**Environmental
Planning
Commission**

Agenda Number: 7
Project #: PR-2018-001584
Case #: RZ-2018-00047,
SI-2018-00221
Hearing Date: December 13, 2018

Staff Report

Agent	Dekker/Perich/Sabatini
Applicant	Presbyterian Healthcare
Request	Zone Map Amendment and Site Development Plan for Building Permit.
Legal Description	All or Portion of Tract 3 plat of tracts 1 thru 4 Coors village
Location	SW corner of Coors Boulevard and Western Trail NW
Size	6.8 acres and 13.54 acres
Existing Zoning	MX-L
Proposed Zoning	MX-M

SITE PLAN REDUCTIONS

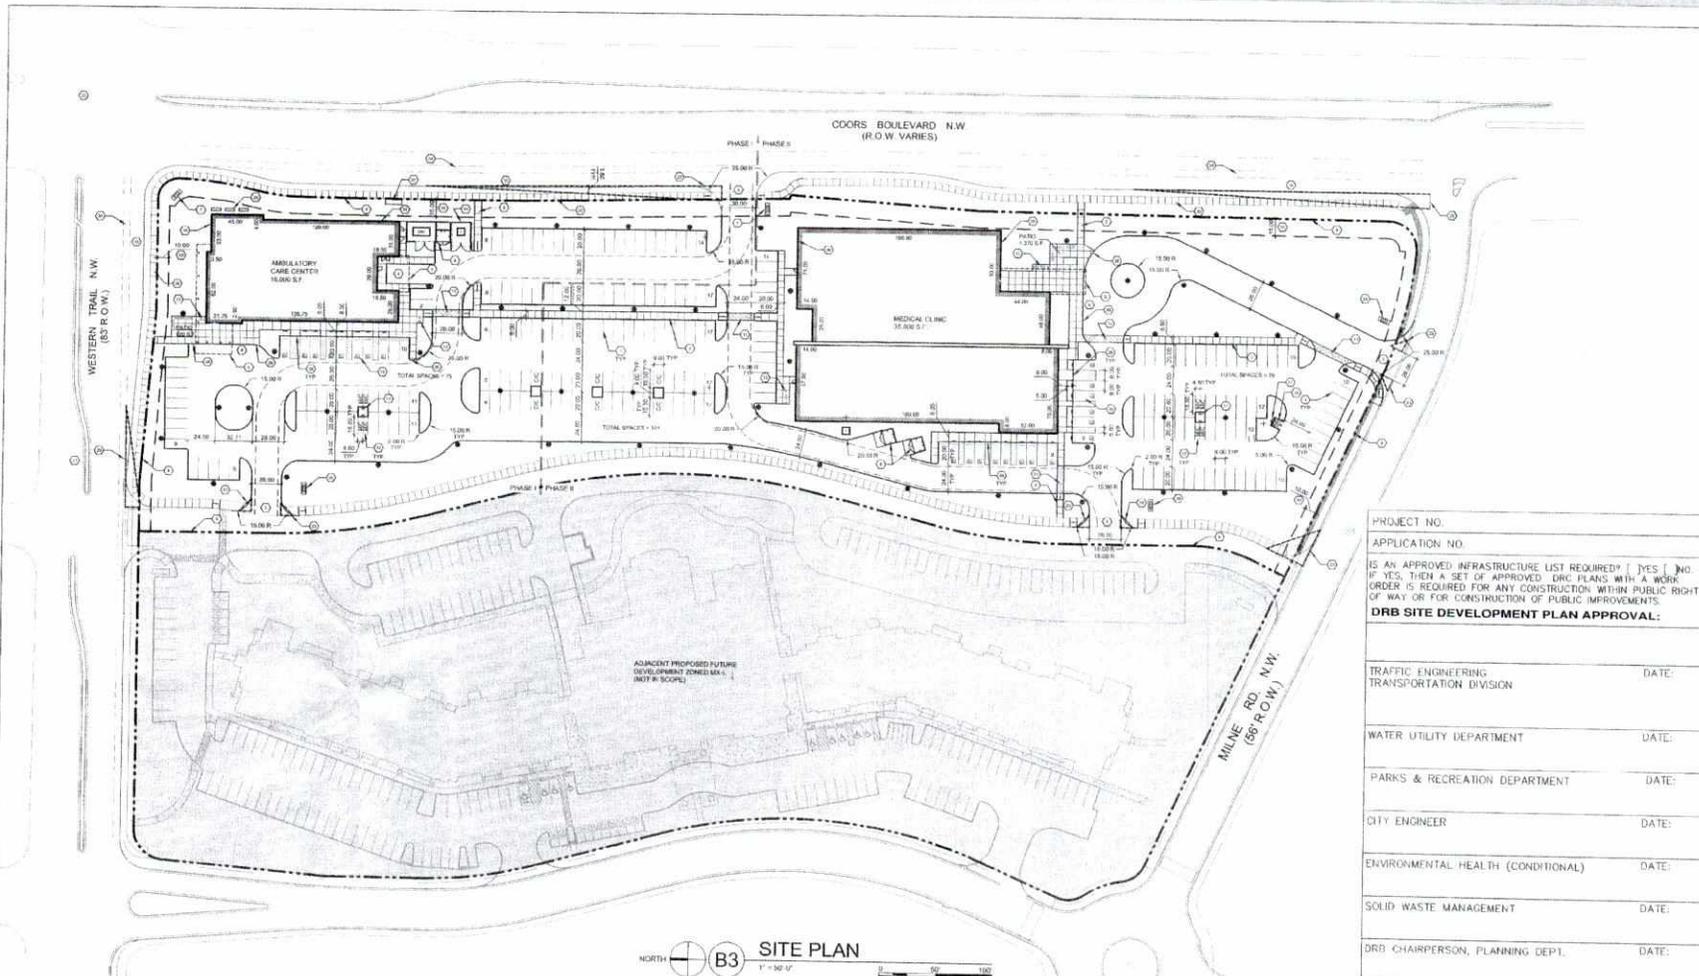
1. Vicinity Map on Sheet SDP1-1 needs the Zone Atlas page listed.
2. Motorcycle parking needs to be dimensioned.
3. Label the compact parking spaces by placing the words "COMPACT" on the pavement of each space.

- 1. Vicinity Map on Sheet SDP1-1 needs the Zone Atlas page listed.**
- 2. Motorcycle parking needs to be dimensioned.**
- 3. Label the compact parking spaces by placing the words "COMPACT" on the pavement of each space.**
- 4. The ADA accessible parking sign must have the required language per 66-7-352.4C NMSA 1978 "Violators Are Subject to a Fine and/or Towing." Please call out detail and location of HC signs.**
- 5. Recheck parking count. Phase I has 84 spaces, not 80 and Phase II count has 147 spaces not 175. Also Phase II has 4 MC spaces not 5.**
- 6. Per DPM, a 6 ft. wide ADA accessible pedestrian pathway is required from the HC parking stall access aisles to the building entrances. Please clearly show this pathway and provide details.**
